October 26, 2009

RE: BLACKBROOK VALLEY ESTATE  
PORTAGE COUNTY  
PERMIT NO. 3PG00093

On September 29, 2009, a follow-up inspection of the above referenced facility's wastewater treatment system was conducted. No one was present during the inspection. The last inspection was on April 29, 2009.

Figure 1

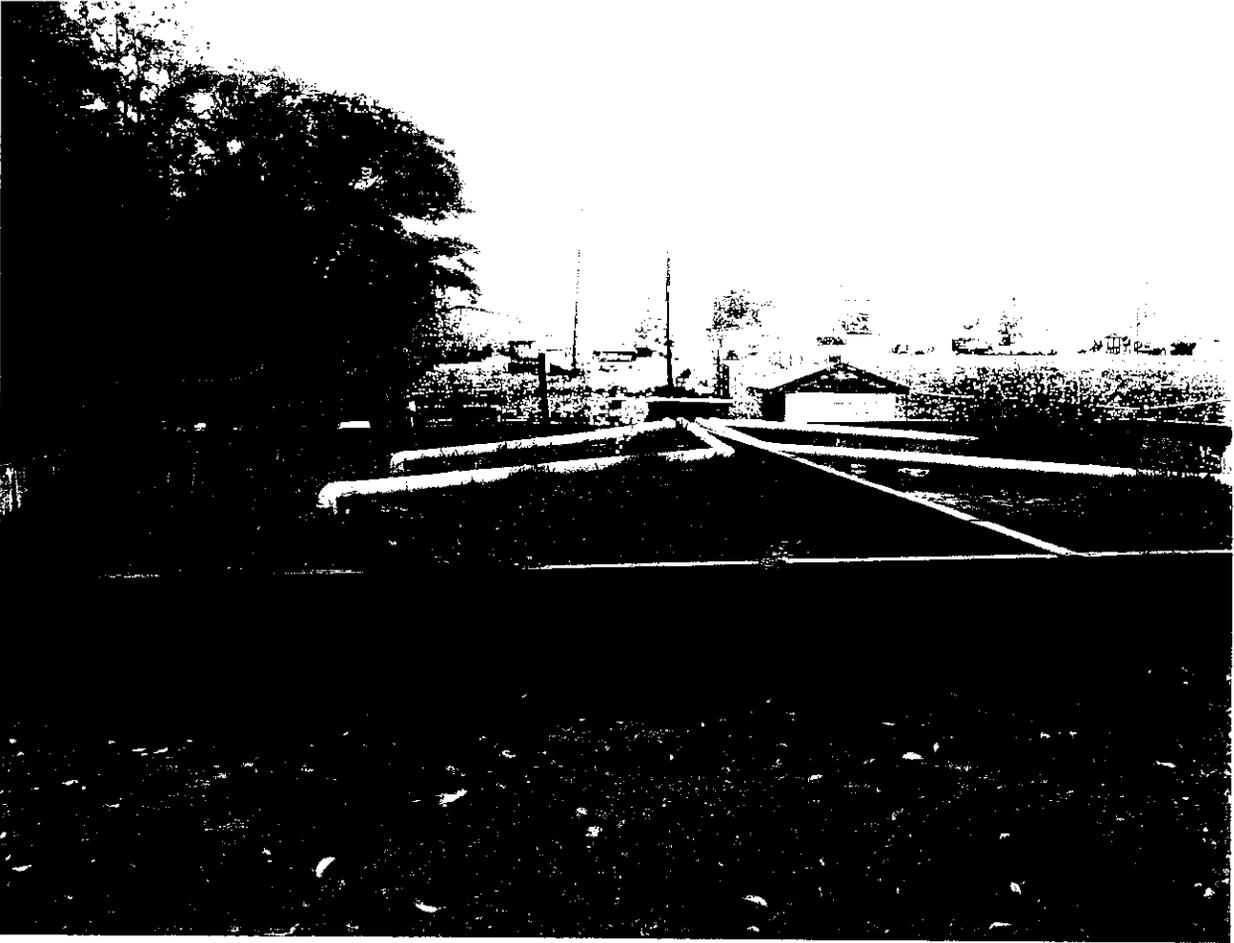
1. All vegetation and sludge dumped along the outside perimeter walls of the filter beds as cited in this office's last correspondence dated May 12, 2009 was removed.
2. The surface sand filter beds were overgrown with vegetation. See Figure 1. The vegetation should be removed immediately. All vegetation should be properly disposed at a licensed landfill.
3. Once the vegetation is removed in the surface sand filter beds, additional filter media may be required. In general 18 inches of approved filter sand is necessary. Any filter sand that is used must meet the requirements of Ohio Administrative Code (OAC) 3745-42-09. More specifically, for conventional surface sand filters, filter sand shall be washed and free of silt; have an effective size of 0.4 mm to 1.0 mm; and have a uniformity coefficient less than 3.0.

**Please inform this office in writing, within 14 days receipt of this letter your intentions to address items 2 and 3. In addition, please indicate if any surface sand filter media was added since the last inspection on April 29, 2009. A response letter from Mr. Josh Goodridge was received by this office dated May 26, 2009. The letter stated that after the sand beds were cleaned they would be probed to determine how much sand would be needed to add to each bed. The letter should include dates either actual or proposed for completion of the actions. A follow-up inspection will be conducted subsequent to the completion date.**
